SB-10056378-9801

SERVICE BULLETIN

ALTIMA; EXHAUST MANIFOLD AND THREE WAY CATALYST SERVICE INFORMATION

Figure 1

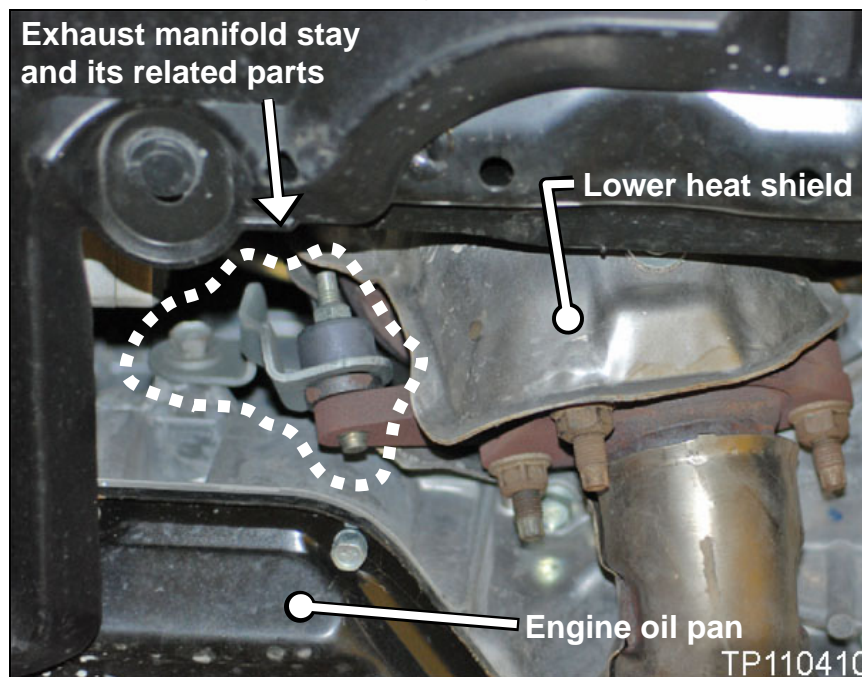
When an exhaust manifold and three way catalyst assembly is removed from an applied vehicle for any reason:

1. Remove and discard the exhaust manifold stay and its related parts.
 2. The upper and lower exhaust manifold covers (heat shields) may need to be replaced.
- Refer to the **FLOW CHART** on page 3 for detailed vehicle applicability.

FLOW CHART

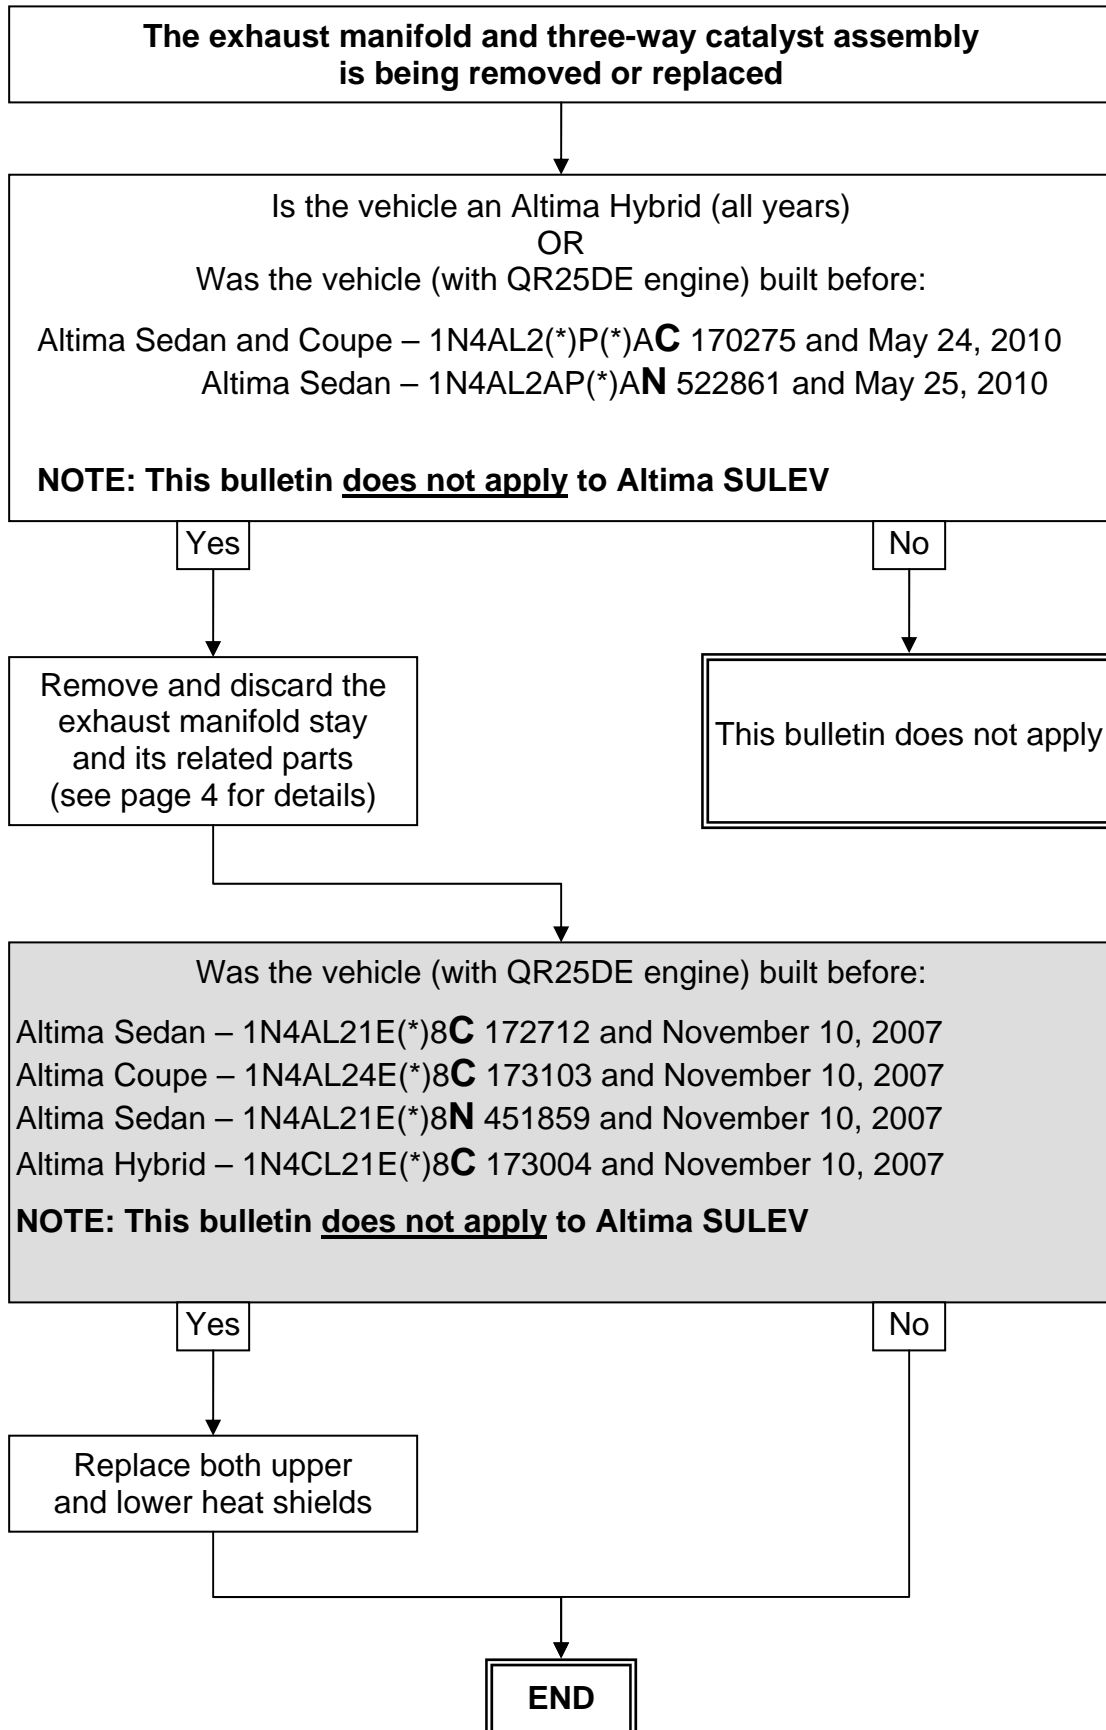
* Applies only to the following vehicles (with QR25DE engine) built before these VINs and dates:

- Altima Sedan – 1N4AL21E(*)8**C** 172712 and November 10, 2007
- Altima Coupe – 1N4AL24E(*)8**C** 173103 and November 10, 2007
- Altima Sedan – 1N4AL21E(*)8**N** 451859 and November 10, 2007
- Altima Hybrid – 1N4CL21E(*)8**C** 173004 and November 10, 2007

Figure 2

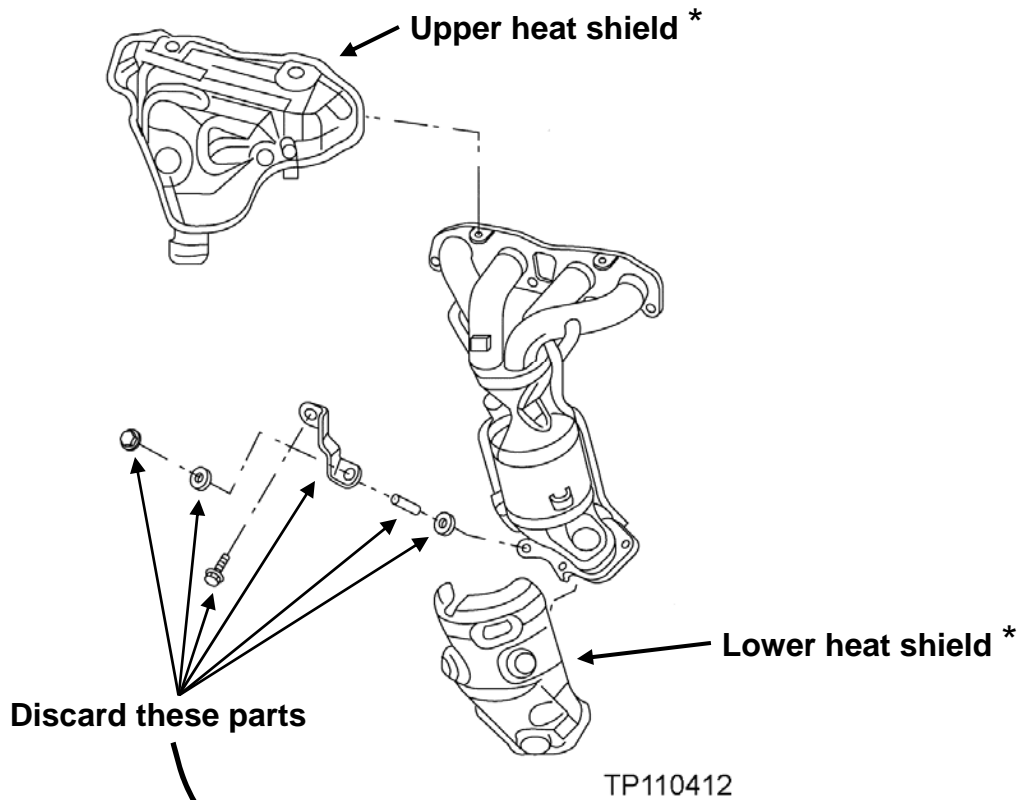
1. Discard the parts as noted in Figure 2 and 3.
2. **ONLY IF IT APPLIES***: Replace the upper and lower heat shields shown in Figure 2 with the ones listed in **PARTS INFORMATION** (see gray box in the **FLOW CHART**, page 3).
